**ADDENDUM NO. ONE (1)**

Date: September 30, 2020 Architect's Project No. 20-19102.10

**PROJECT: GWINNETT COUNTY POLICE TRAINING INDOOR FIRING RANGE HVAC UPGRADE PROJECT, BL089-20**

**SHEET NO.** **M2.0**

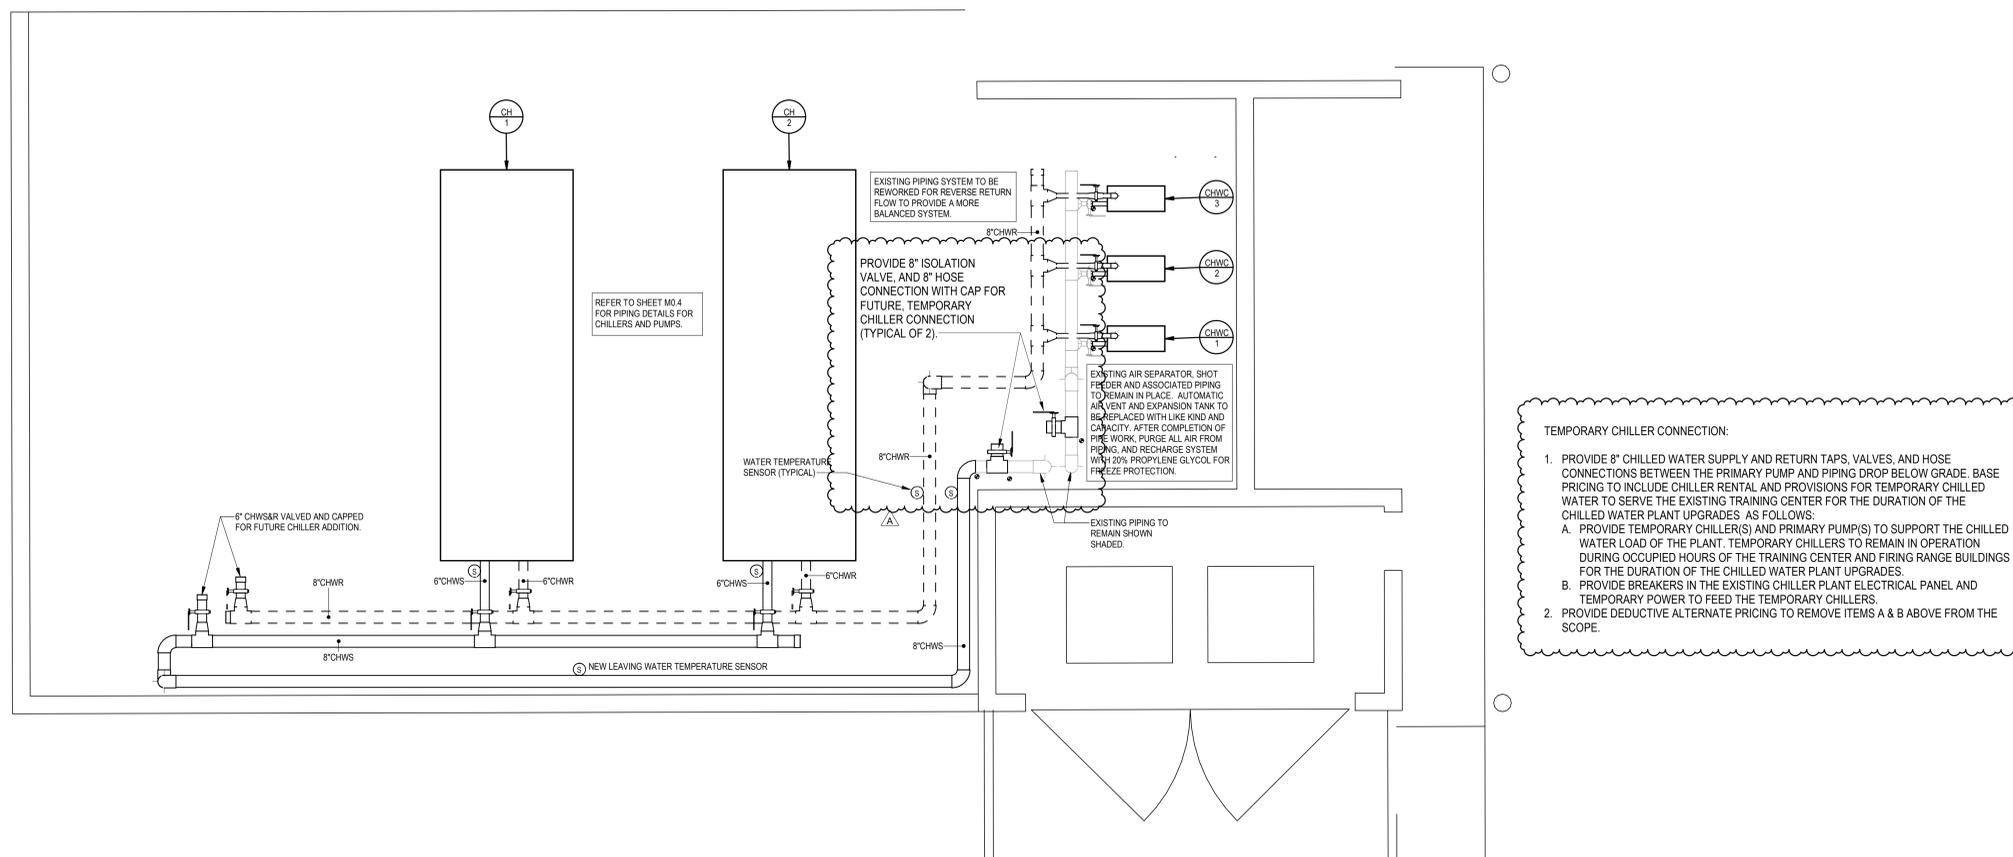
**TEMPORARY CHILLER CONNECTION:**

- PROVIDE 8" CHILLED WATER SUPPLY AND RETURN TAPS, VALVES, AND HOSE CONNECTIONS BETWEEN THE PRIMARY PUMP AND PIPING DROP BELOW GRADE. BASE PRICING TO INCLUDE CHILLER RENTAL AND PROVISIONS FOR TEMPORARY CHILLED WATER TO SERVE THE EXISTING TRAINING CENTER FOR THE DURATION OF THE CHILLED WATER PLANT UPGRADES. AS FOLLOWS:
  - PROVIDE TEMPORARY CHILLER(S) AND PRIMARY PUMP(S) TO SUPPORT THE CHILLED WATER LOAD OF THE PLANT. TEMPORARY CHILLERS TO REMAIN IN OPERATION DURING OCCUPIED HOURS OF THE TRAINING CENTER AND FIRING RANGE BUILDINGS FOR THE DURATION OF THE CHILLED WATER PLANT UPGRADES.
  - PROVIDE BREAKERS IN THE EXISTING CHILLER PLANT ELECTRICAL PANEL AND TEMPORARY POWER TO FEED THE TEMPORARY CHILLERS.
- PROVIDE DEDUCTIVE ALTERNATE PRICING TO REMOVE ITEMS A & B ABOVE FROM THE SCOPE.

**Answer:** Base price to include temporary chilled water. Provide a deductive alternate to remove the temporary cooling scope.
3. **Question:** Will we be providing test & balance for the entire chilled water loop?

SHEET NO. M3.0

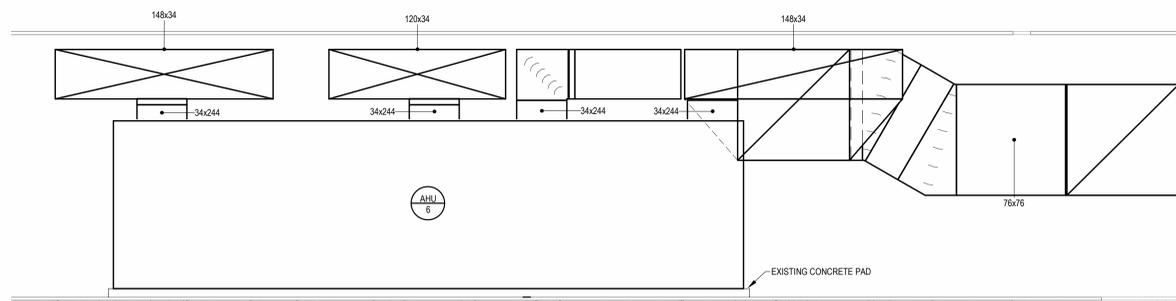
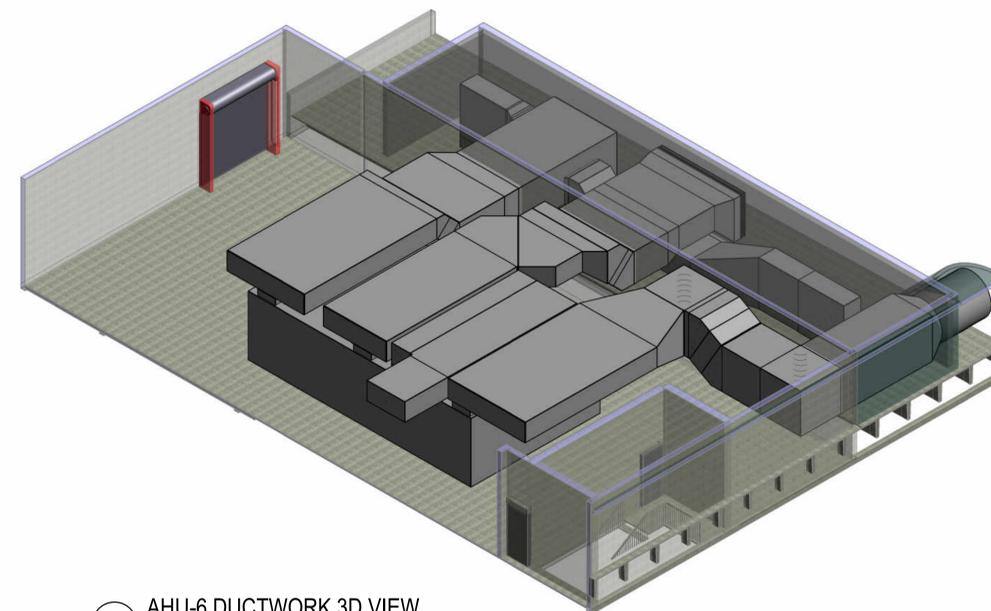
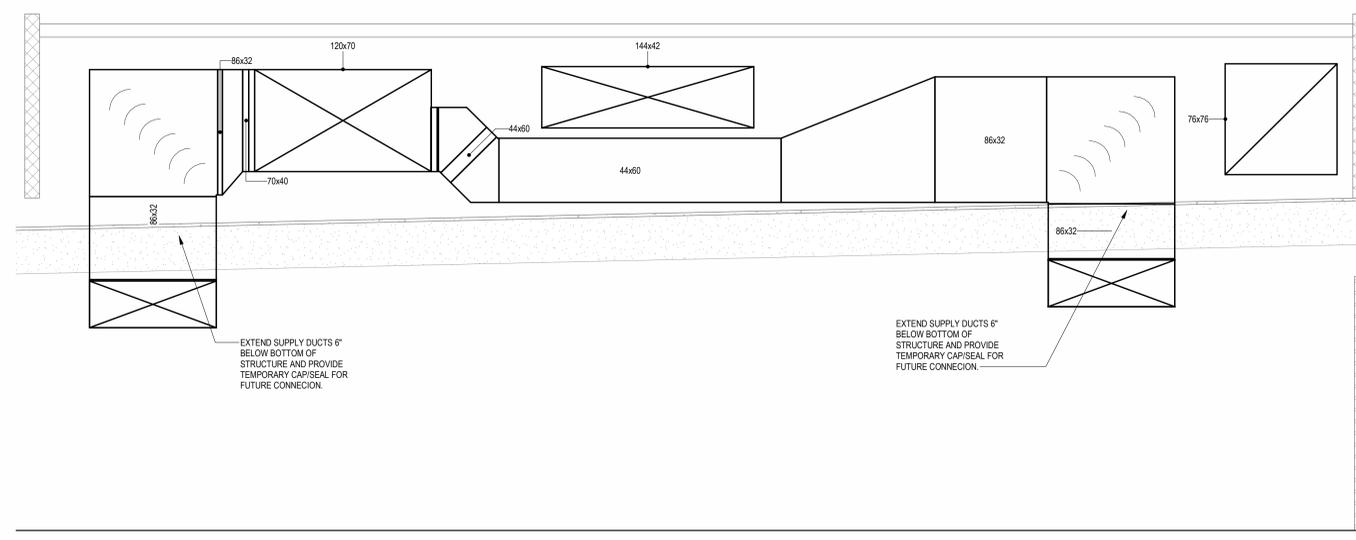
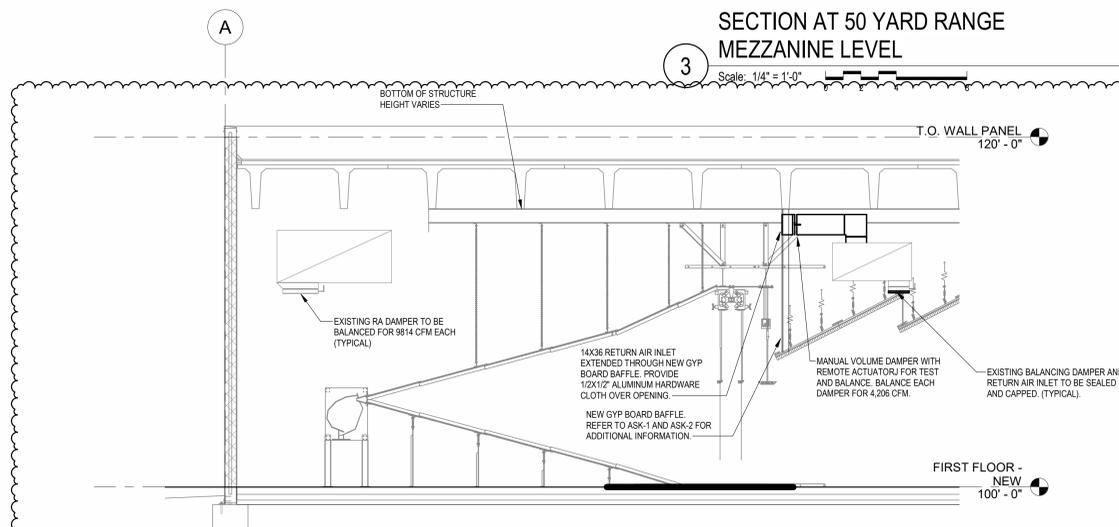
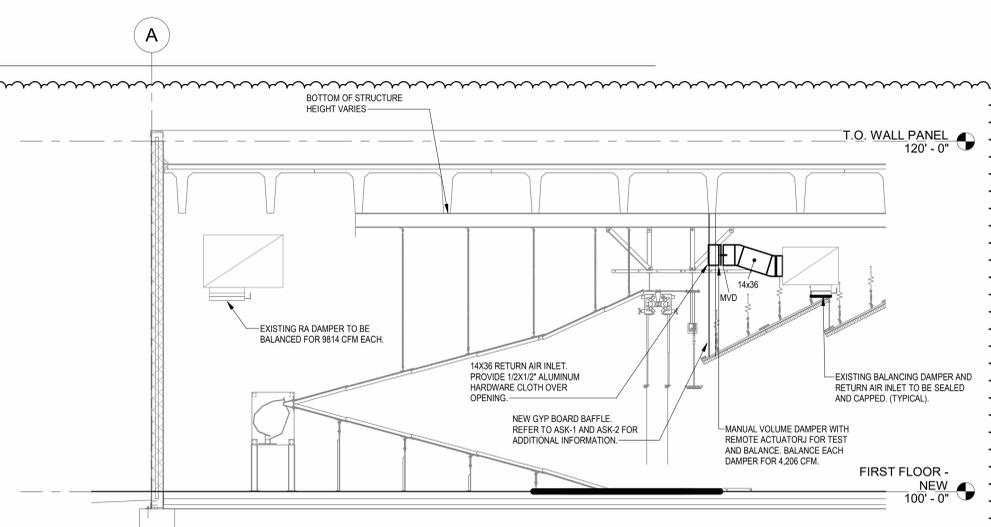
5. **Question:** During the walk through we noticed a 4th roof stack that does not look to be utilized inside the mechanical room for the fresh air intake. Will we be able to utilize the 4th vent/penetration for a fresh air supply for AHU6?

**Answer:** Yes, Addendum No. 1 drawings are revised to show connection to the existing stack.
6. **Question:** Will we be able to visit the site a second time to look at the job again before the bid is due?
